17-084MPR – REVELRY TAVERN SIGN

Reviewing Board

Minor Project Review for an illuminated wall sign for a tenant space within the Dublin Village Center.

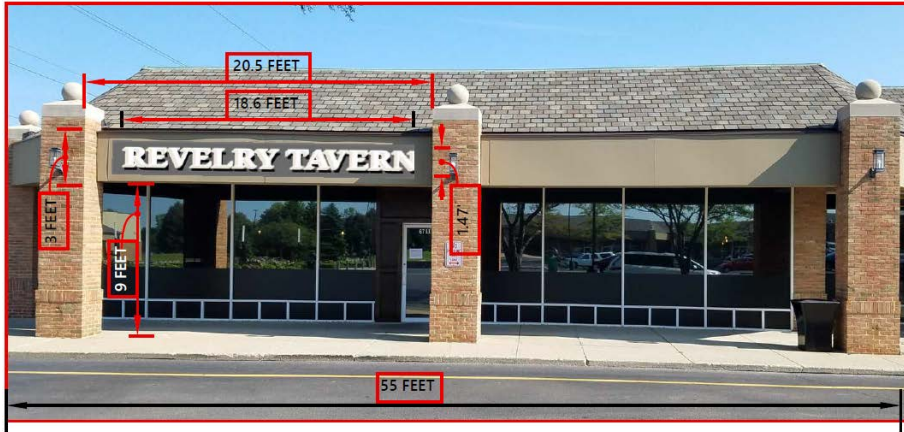
This proposal is for an internally illuminated, channel letter wall sign for an existing multiple tenant building within the Dublin Village Center. The sign will be located on the structure's existing sign band facing Federated Boulevard. For this proposed wall sign, code permits a maximum sign size of 55 square foot and a maximum height of 15 feet. The sign is proposed to be 27.34 square feet in area at a height of approximately 11 feet above grade. The entirety of the sign is one color as white channel lettering, which meets code requirements, and does not have a secondary image. Overall, this proposal

meets all applicable code requirements regarding size, design, and placement. This application does not include any proposed window signs.

SOUTH STORE FRONT DIMENSION = 55 FEET
